Docket Number:	19-SPPE-02
Project Title:	Walsh Data Center
TN #:	232974
Document Title:	Intervenor Sarvey's Opening Testimony
Description:	Opening testimony of Robert Sarvey
Filer:	Robert Sarvey
Organization:	Robert Sarvey
Submitter Role:	Intervenor
Submission Date:	5/13/2020 3:38:02 PM
Docketed Date:	5/13/2020

Walsh Data Center

Docket 19-SPPE-02

Intervenor Sarvey's Opening Testimony

Santa Clara Data Centers Under Commission Review and Distance between SDC and Walsh Avenue DC

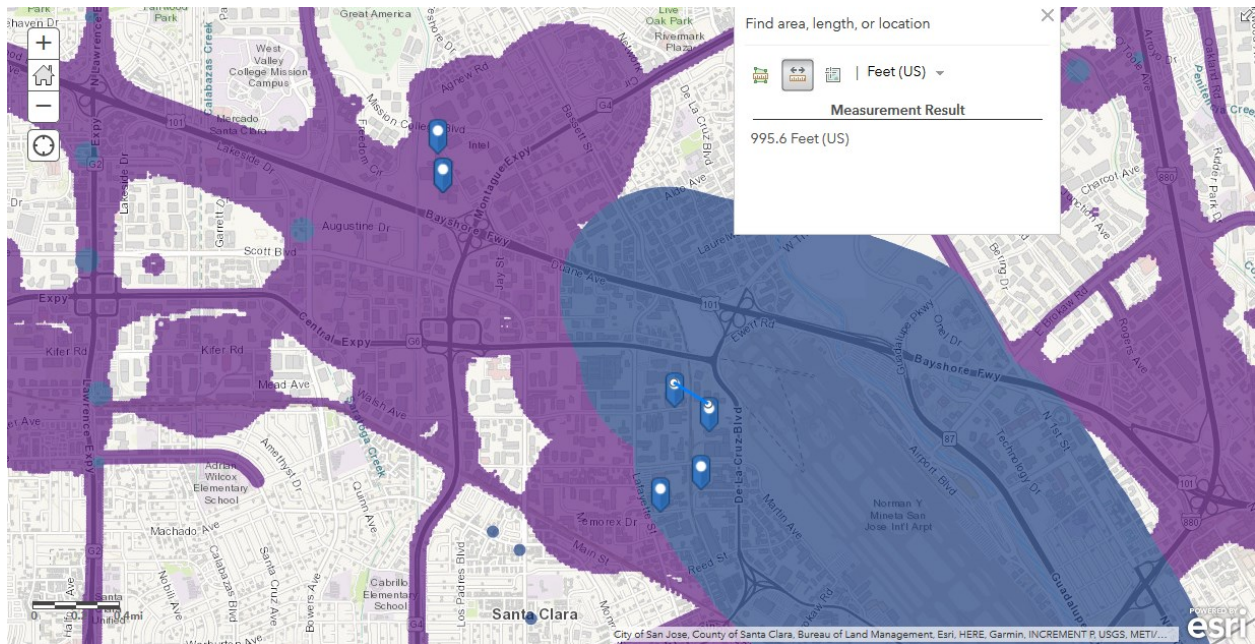
As noted above, Air District guidance recommends expanding the project radius when large complex sources are nearby. The Energy Commission is currently processing six data centers in addition to the McLaren Data Center and Laurelwood Data Center which were recently approved. One of the data centers, the Sequoia Data Center, currently under Energy Commission review is less than 1,000 feet from the SDC as depicted in the map below.

BAAQMD has determined that the project area shaded in blue in the map above requires further study. BAAQMD Planning Healthy Places handbook on page 12 describes the blue shaded project area in the map above. The handbook states,

Data Centers Currently Operating in Santa Clara

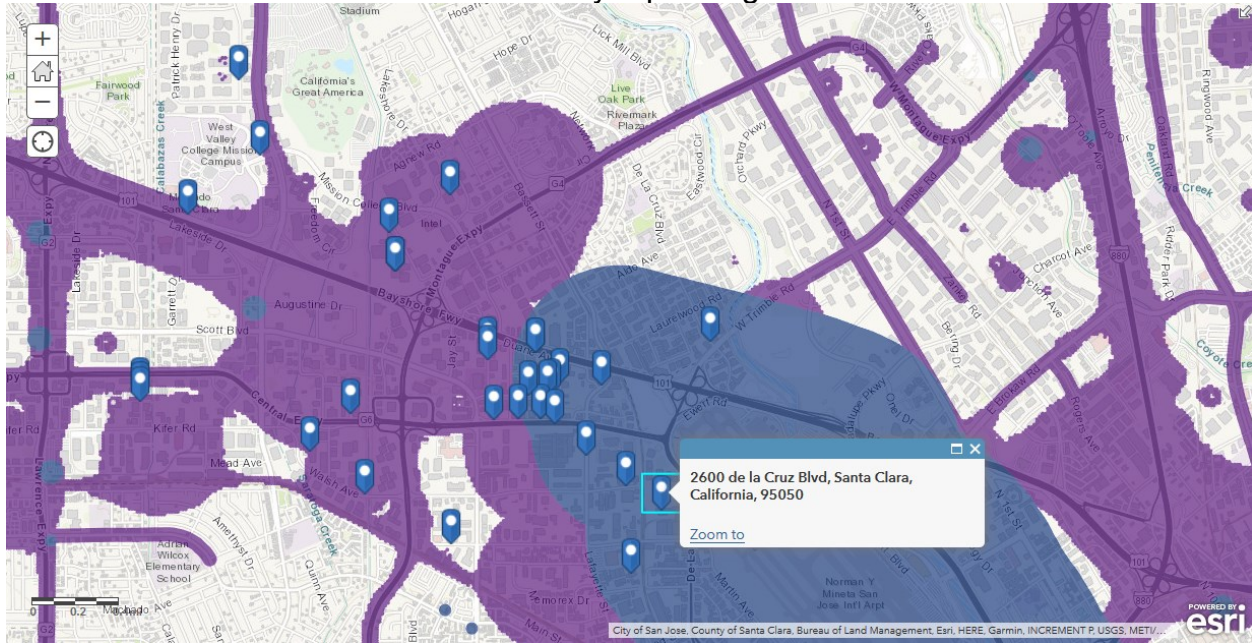
The City of Santa Clara is currently host to 50 existing data centers⁴⁴ clustered in a three and a half square mile area. The publicly available locations of data centers are on the map below.

Data Centers recently approved by the City of Santa Clara

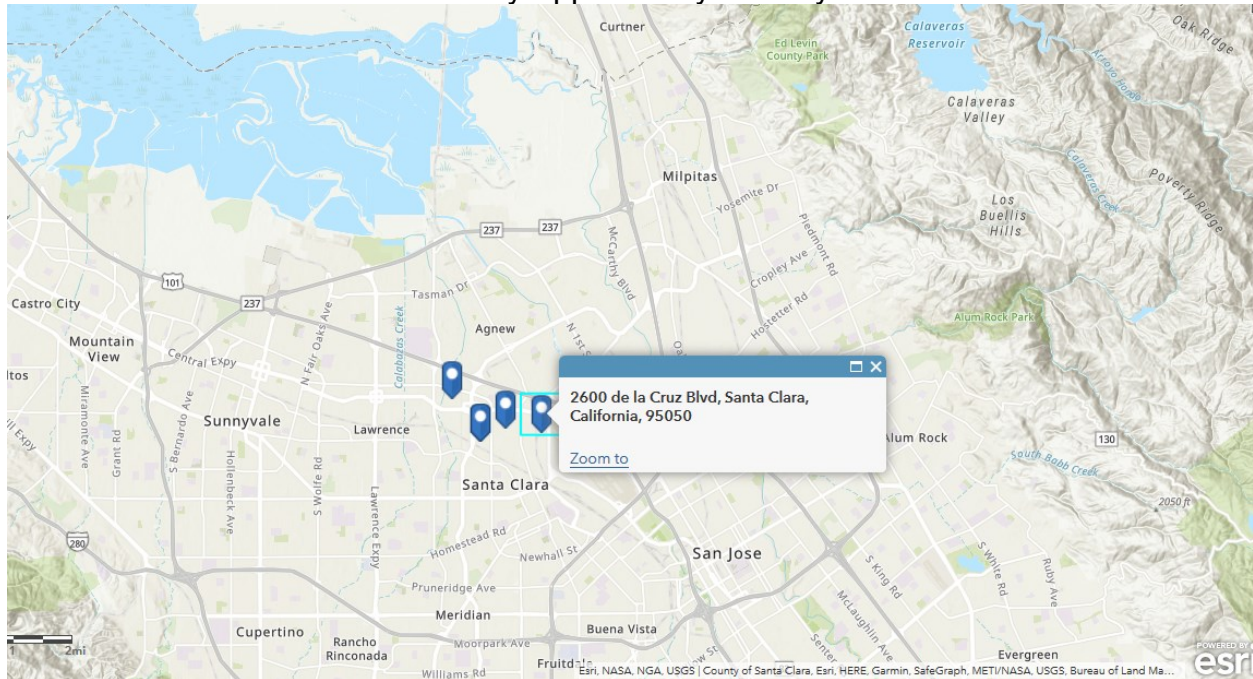
produce 12.9 tons per year of NOx and .3 tons of diesel particulate matter.⁶¹ The data centers are located on the map below.

As can be seen, the project area is overburdened with pollution before the many new data centers spew their diesel particulate and NOx emissions. A fair argument has been made above that an air quality cumulative impact assessment is required for this project due to the existing and future data centers.
